PARTIAL ROOF REPLACEMENT

**STAPLES HIGH SCHOOL
70 NORTH AVENUE
WESTPORT, CT 06880
STATE PROJECT #158-0100 RR
BID #23-009-RFP**

DATE: September 22, 2022

The following changes to the Drawings and Project Specifications shall become a part of the Drawings and Project Specifications; superseding previously issued Drawings and Project Specifications to the extent modified by Addendum #1.

RTU TERMINATION BAR DETAIL
SCALE: 1/4" = 1'-0"

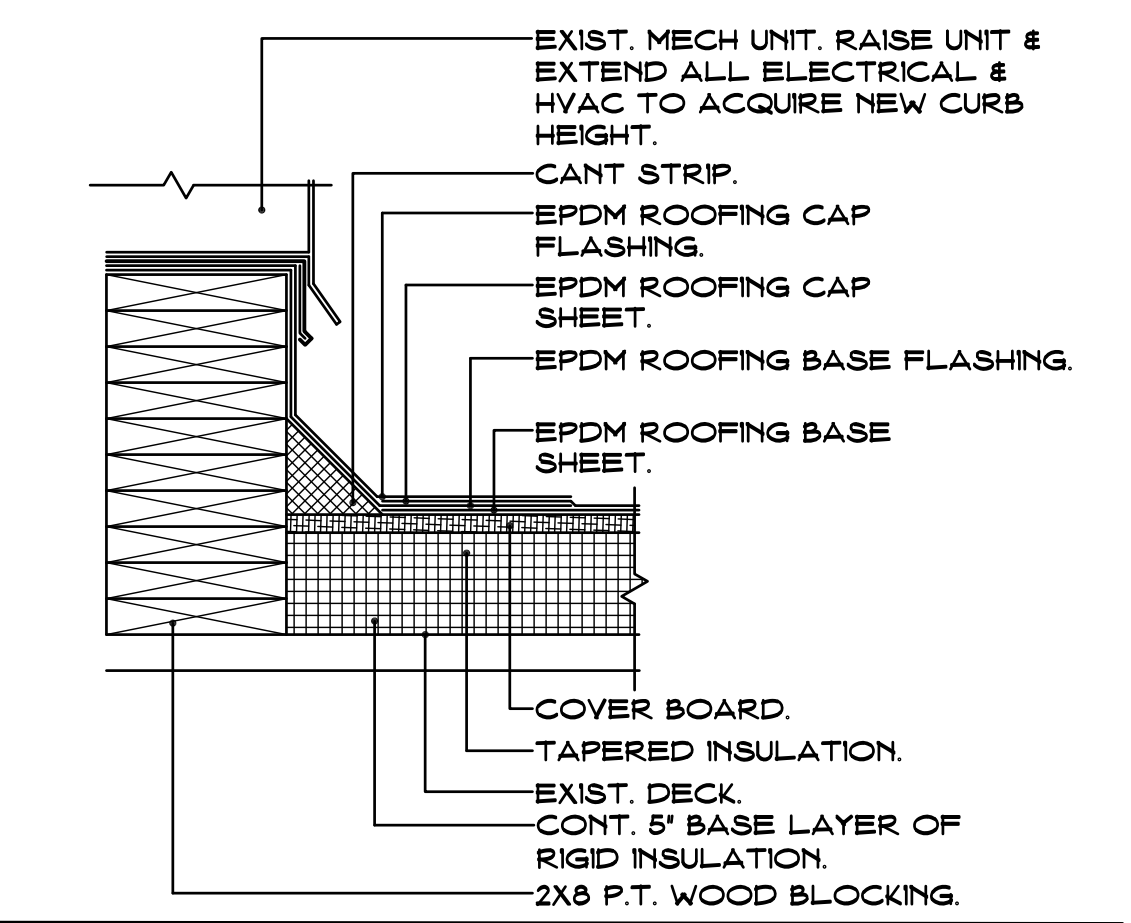
NOTE: EXIST. MECHANICAL UNIT TO BE REMOVED & REINSTALLED AS REQUIRED FOR NEW CURB & ROOFING OPERATIONS. EXTEND ALL ELECTRICAL WIRING & DUCTWORK AS REQUIRED.

Drawing Title:
Roof Plan Part 2
STATE PROJECT #158-0100 RR

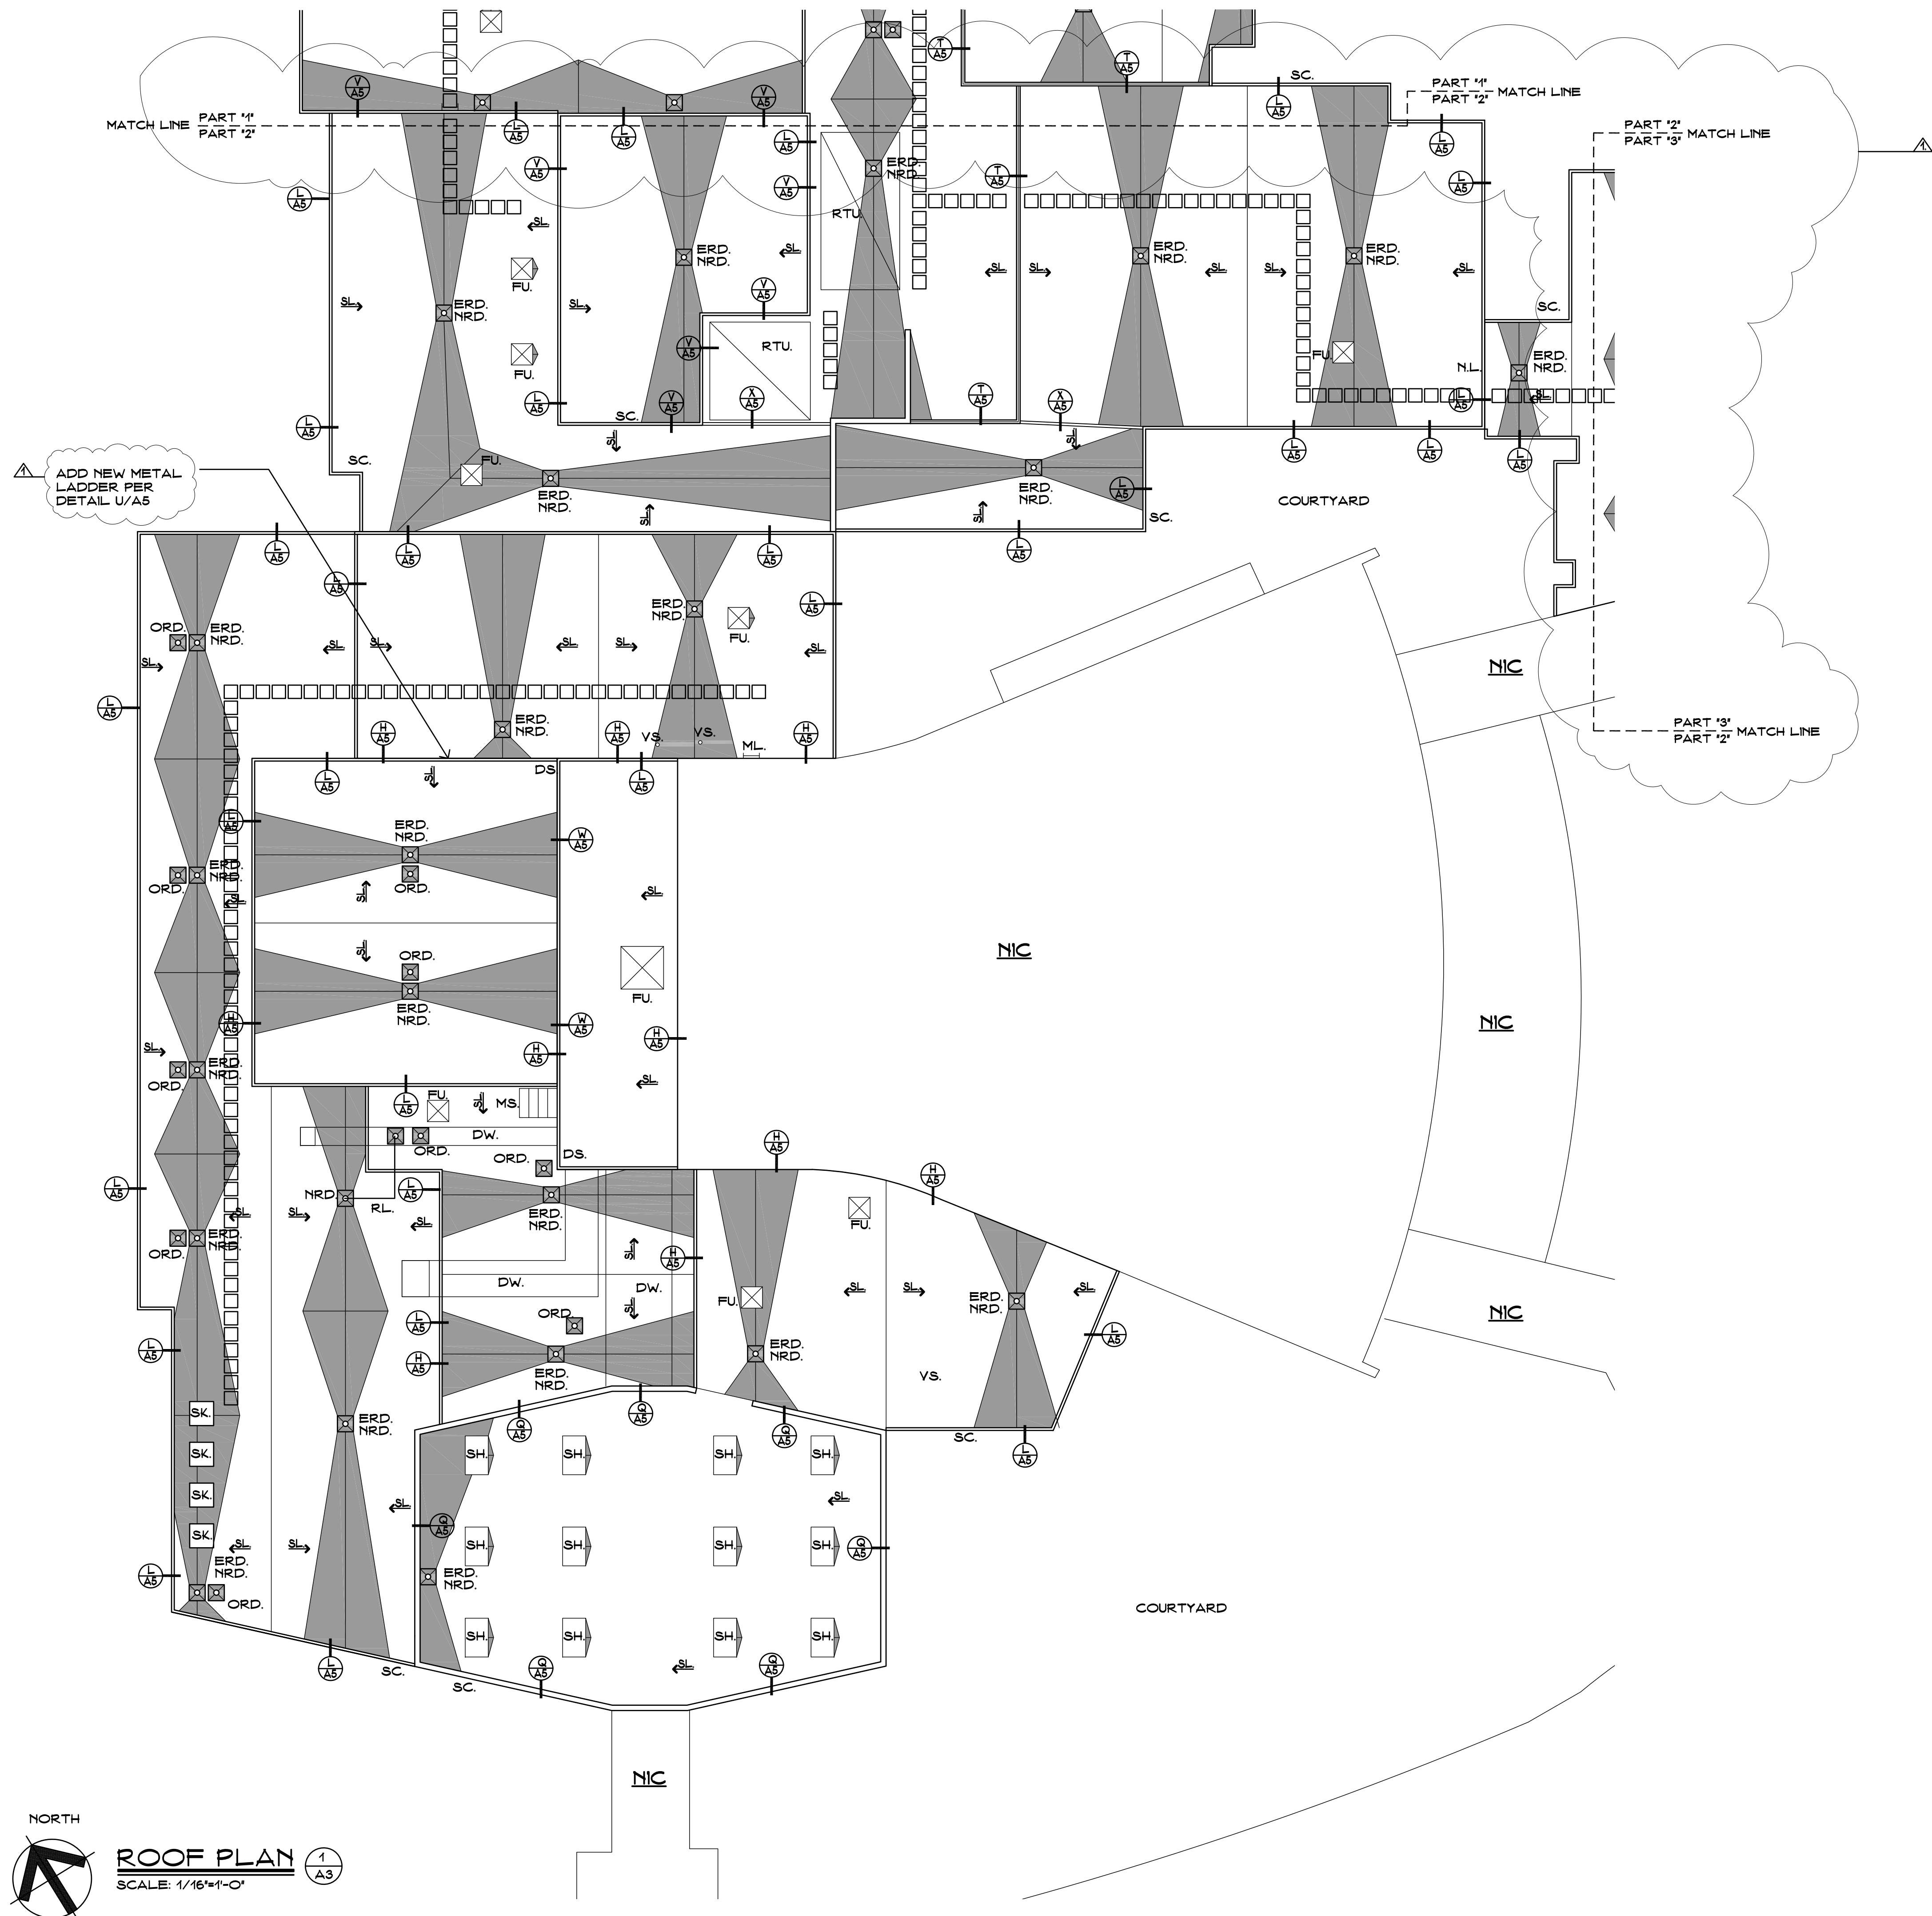
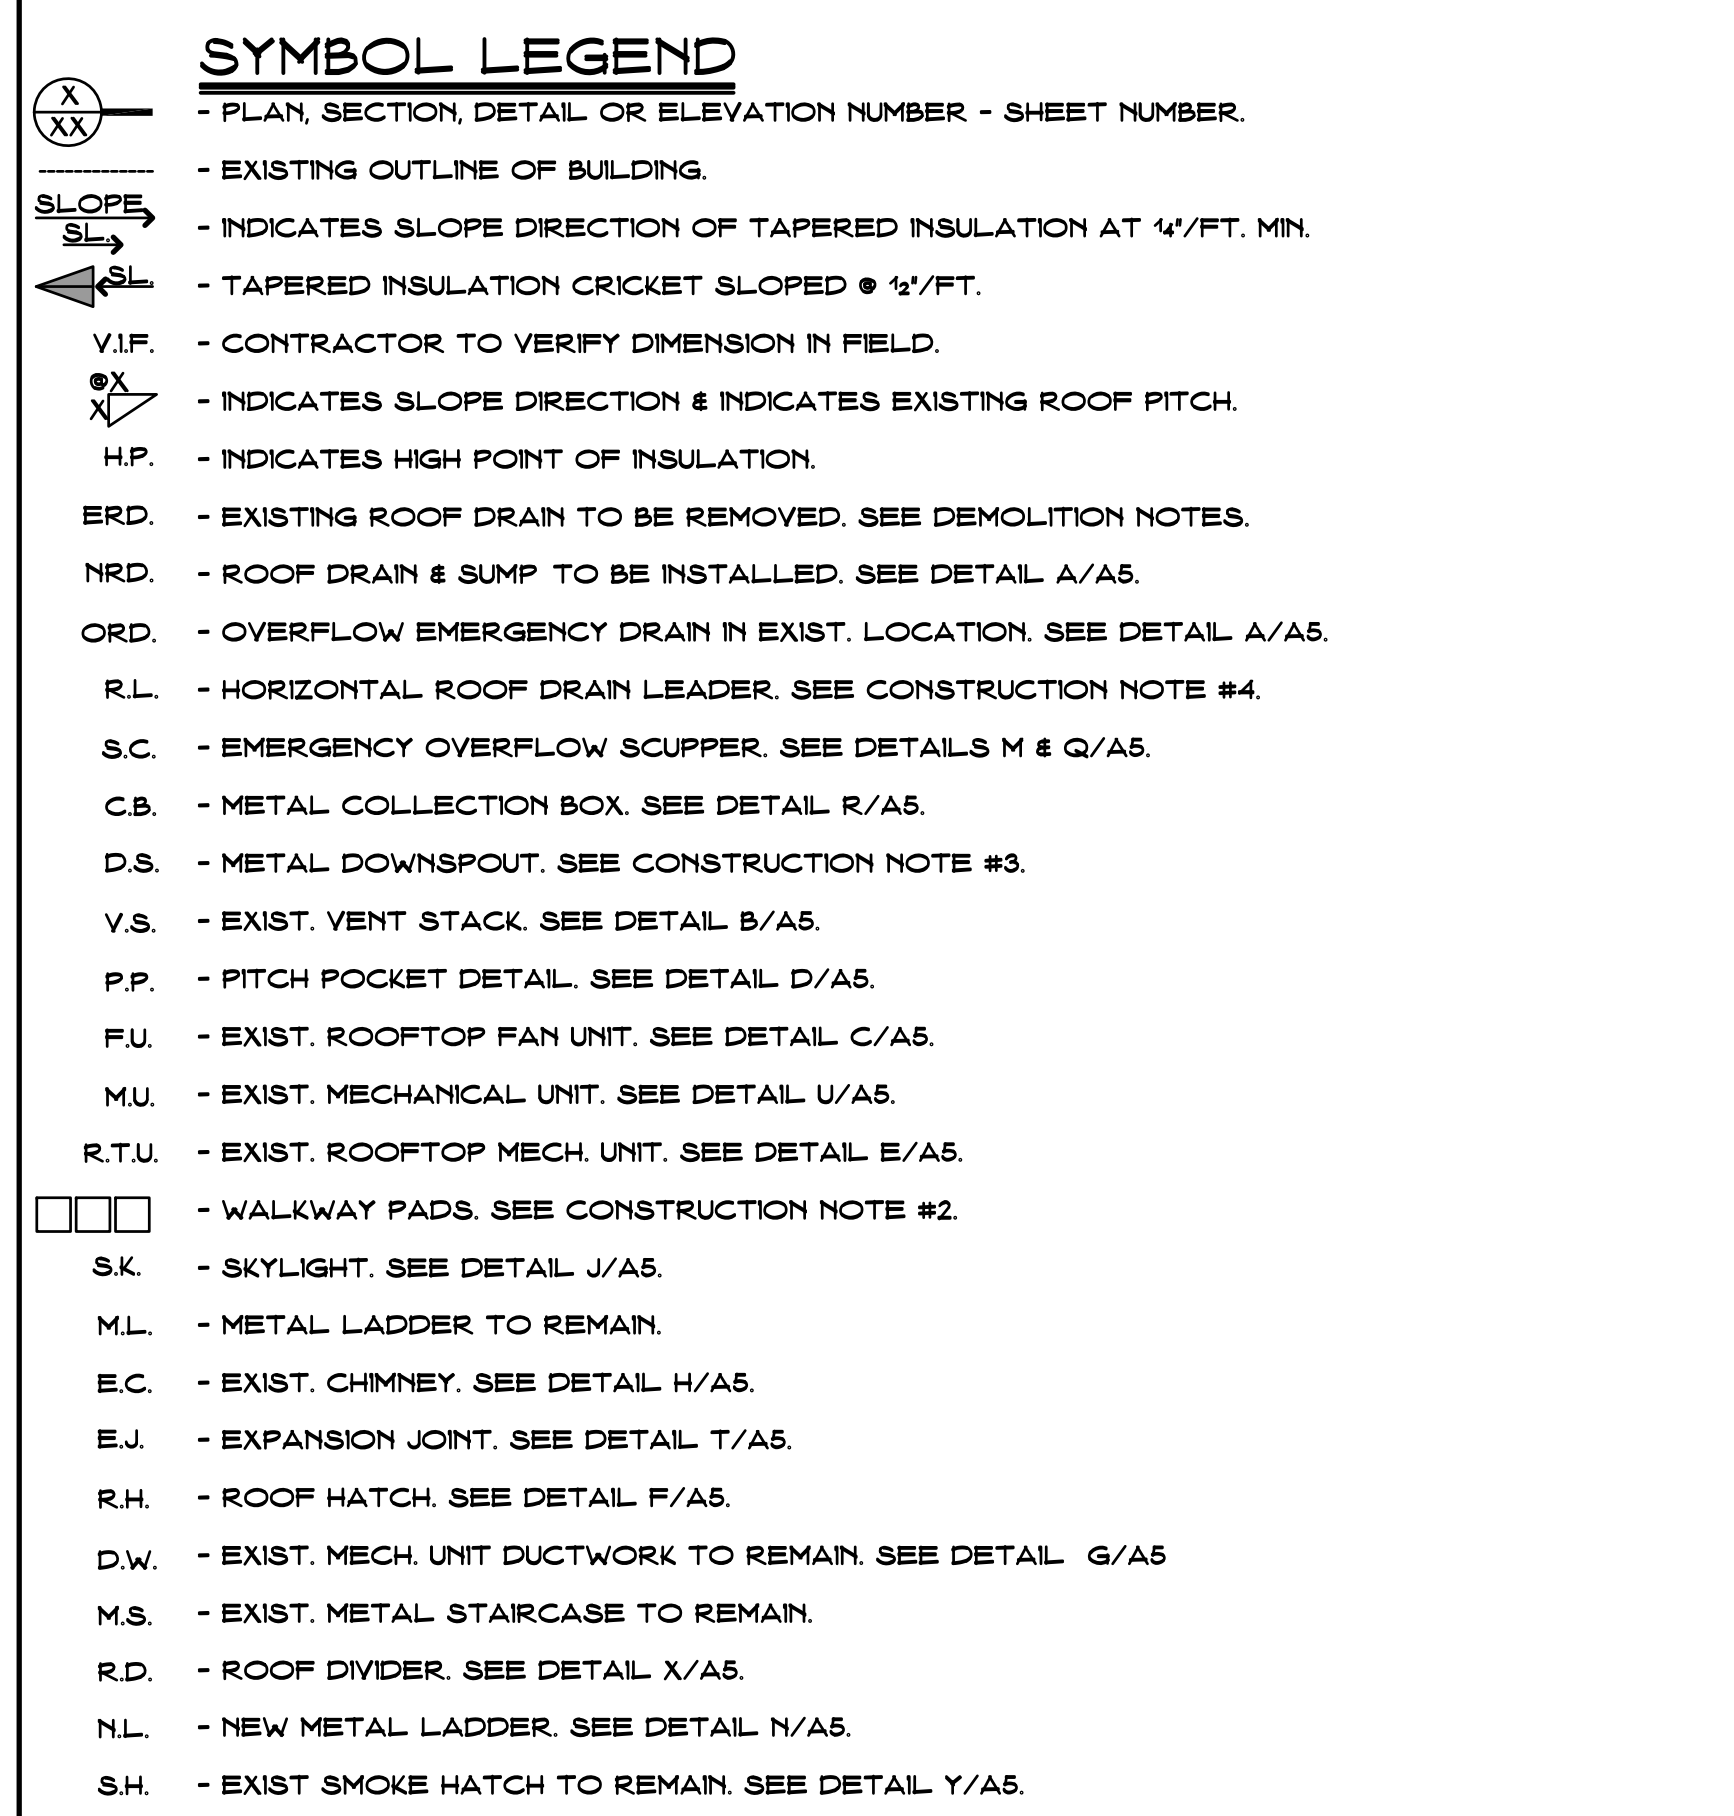
- The following ARCHITECTURAL drawings have been deleted in their entirety. New drawing has been added and are attached as part of this addendum.*
 - A2 ROOF PLAN PART #1
 - A3 ROOF PLAN PART #2
 - A4 ROOF PLAN PART #3 (*Per RFI #s 002, 003 & Internal Review*)
- DRAWING C1, CODE INFORMATION:
 - General Notes, add the following:

5. EXIST. ELECTRICAL CONDUIT TO REMAIN. CONTRACTOR TO TEMPORARILY REMOVE & REINSTALL PER NEW ROOF INSULATION HEIGHTS. SEE DETAIL K/A5.
6. EXISTING GAS PIPING TO BE DISCONNECTED & PURGED. RAISE EXISTING GAS PIPING AS REQUIRED TO ACCOMMODATE NEW ROOFING INSULATION HEIGHTS. PROVIDE NEW PIPING EXTENSIONS, JOINTS & FITTINGS & RECONNECT TO EXISTING GAS MAIN. INSTALL ALL EXIST. & NEW GAS PIPING ON NEW PIPE CURBS 24" O.C. PRIME & PAINT ALL EXISTING & NEW GAS PIPING. SEE PROJECT MANUAL.

7. EXISTING ROOFTOP MECHANICAL UNIT. RAISE ENTIRE UNIT MIN. 8" ABOVE HIGH POINT OF NEW ROOF INSULATION. EXTEND ALL DUCTWORK & ELECTRICAL WIRING. SEE DETAIL A/A2 & PROJECT MANUAL.

8. ALL EXISTING METAL STAIRCASES ARE TO BE TEMPORARILY REMOVED DURING CONSTRUCTION. MODIFIED AS NEEDED TO COMPENSATE FOR NEW ROOF INSULATION HEIGHTS & REINSTALLED.
